Subject: Transmittal of Revision 3 to Service Bulletin Number
V2500-ENG-72-0014

International Aero Engines SERVICE BULLETIN

ENGINE - INCORPORATE RE-ROUTED E.G.T. HARNESS ASSEMBLY

V2500-A1

Replacement of thermocouple box and cable
Figure 1
Sheet 1 of 3

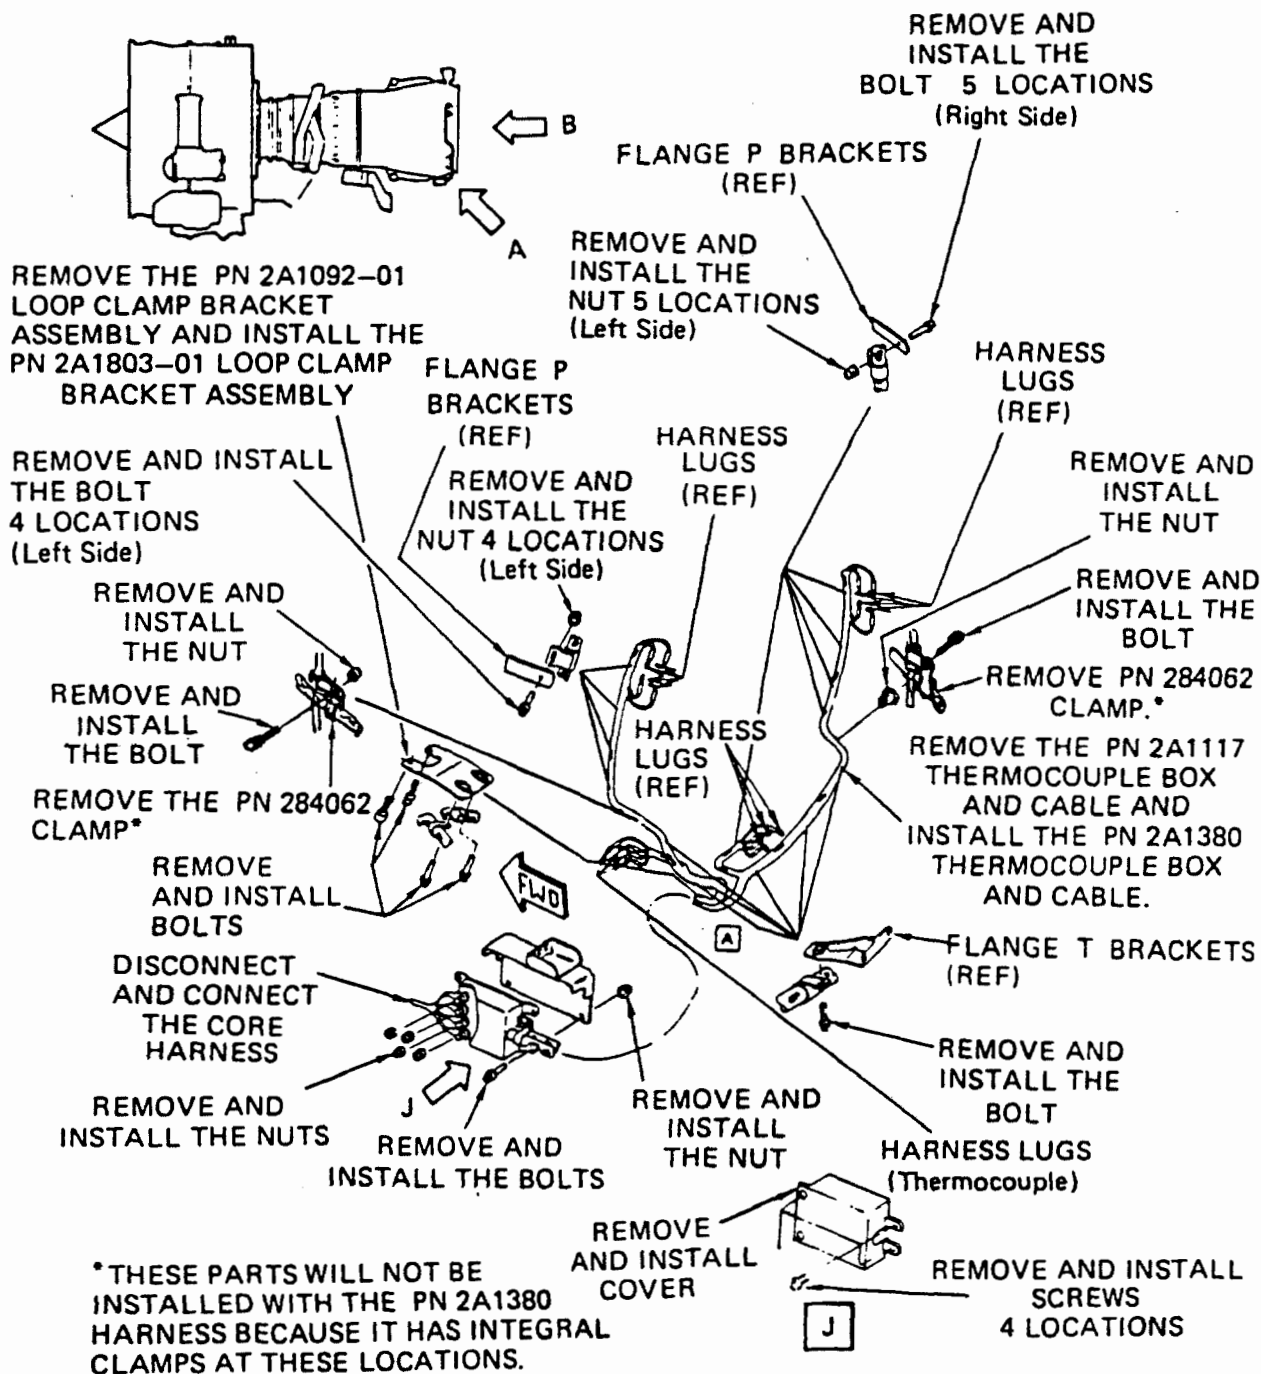
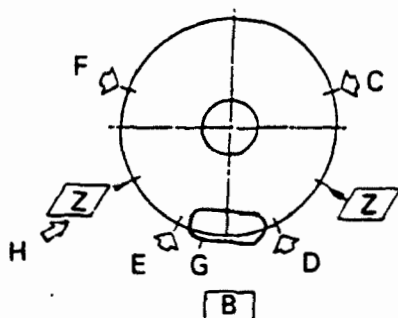
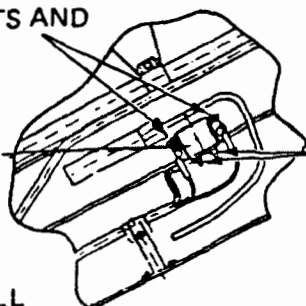
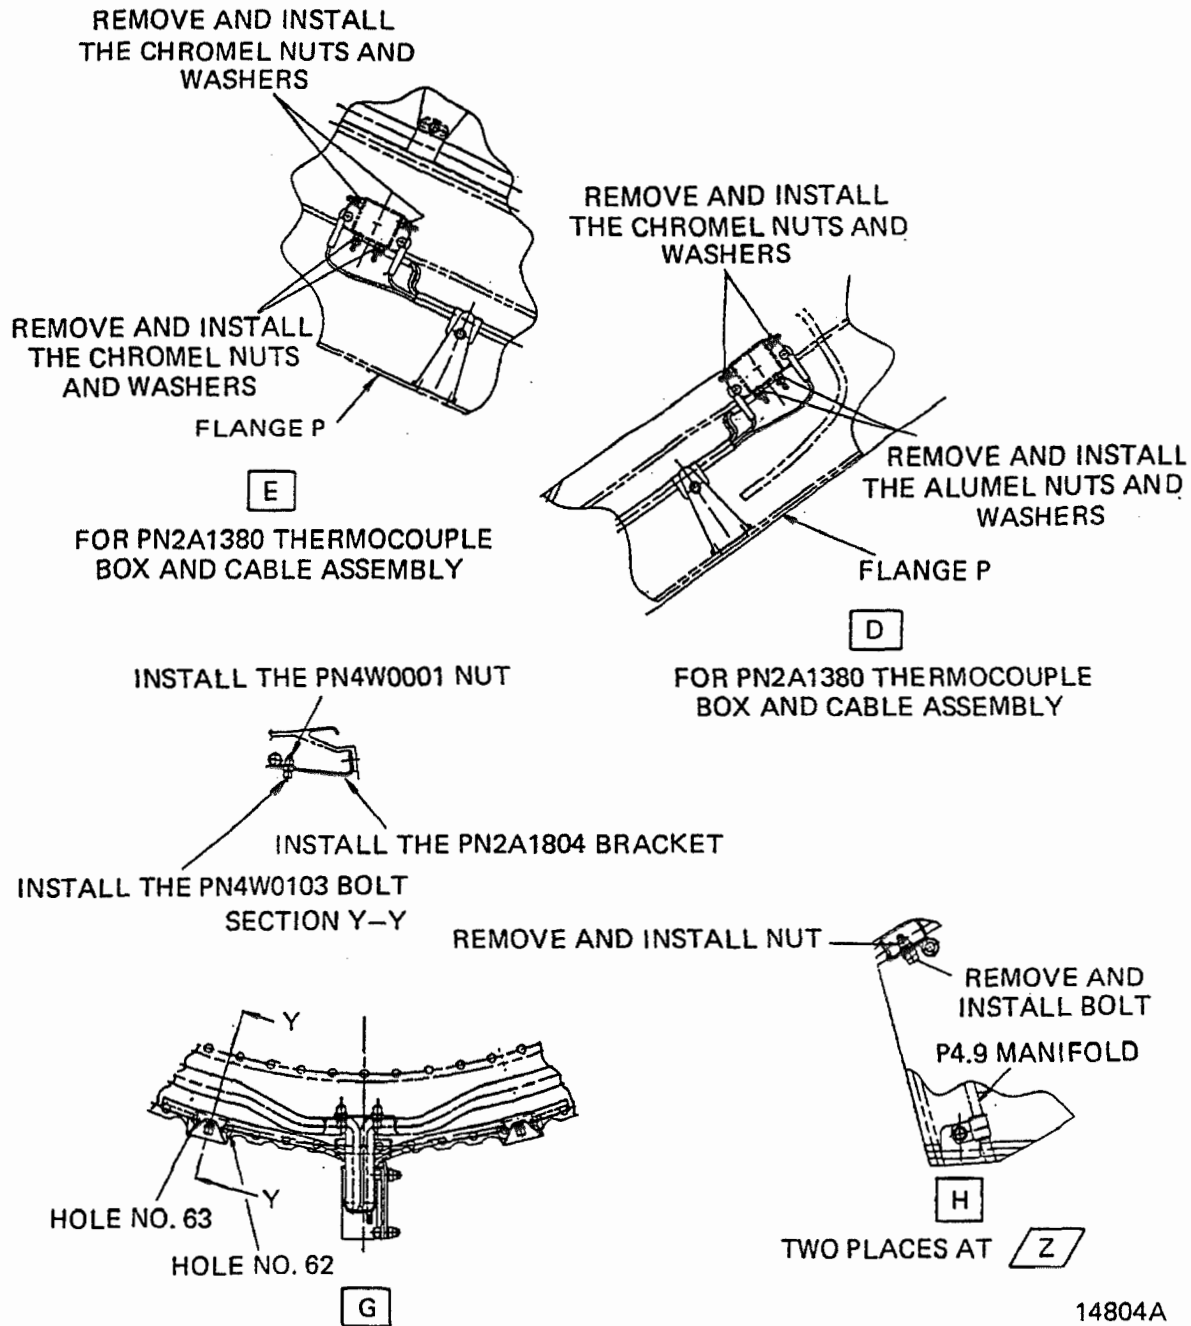
- (1) The thermocouple box and cable is replaced with a new one which has revised length and additional integral clipping. An additional bracket is provided at P flange and the EGT harness bracket assembly is redesigned.

A. Remove the PN 2A1117 Thermocouple Box and Cable by the instructions which follow and Figure 1.

(2) Disconnect the harness at the flange T and flange P bracket locations. Refer to Figure 1.

(3) Disconnect the core EGT harness from the junction box terminals. Refer to Figure 1.

(5) Remove the EGT harness and junction box assembly from the engine. Refer to Figure 1.

B. Remove the PN 2A1092 Loop Clamp Assembly by Figure 1 and as follows:

C. Install the PN 2A1803 Loop Clamp Bracket (1 off) on the P4.9 Pipe Adapter at the 6 o'clock position on the Turbine Exhaust Case, as follows:

D. Install the PN 2A1804 Loop Clamp Bracket (1 off) to P flange on the Turbine Exhaust Case Assembly by Figure 1 and as follows:

E. Install the PN 2A1380 Thermocouple Box and Cable (1 off).

(3) Torque the alumel connection (larger stud) to between 10 and 15 lbfin (1,130 to 1,695 Nm). See Reference (1) Chapter/Section 70-41-00, Torque Tightening Technique.

(4) Torque the chromel connection (smaller stud) to between 8 and 10 lbfin (0,904 to 1,356 Nm). See Reference (1), Chapter/Section 70-41-00, Torque Tightening Technique.

Replacement of Thermocouple Box and Cable
(Removed Parts)

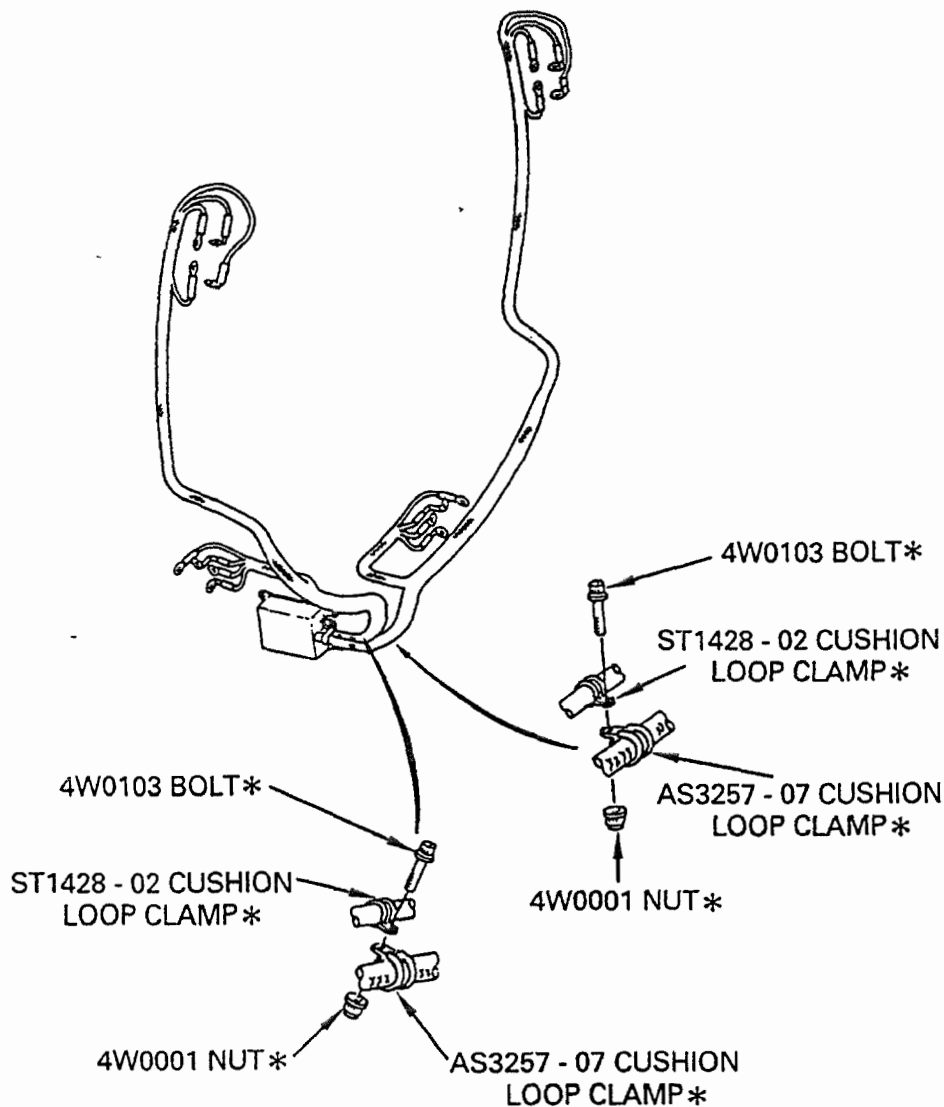
R (4) Remove the Cushion Loop Clamps that hold the EGT Harness to the P4.9 Manifold. See Figure 2.

R (a) Remove the nuts and bolts that connect the cushion loop clamps.

R (b) Remove the cushion loop clamps from the P4.9 manifold.

R (c) Remove the cushion loop clamps from the EGT harness.

R NOTE: The parts removed in step (4) will not be installed again in
R the new configuration.

* THESE PARTS ARE REMOVED AND
WILL NOT BE INSTALLED AGAIN IN
THE NEW CONFIGURATION
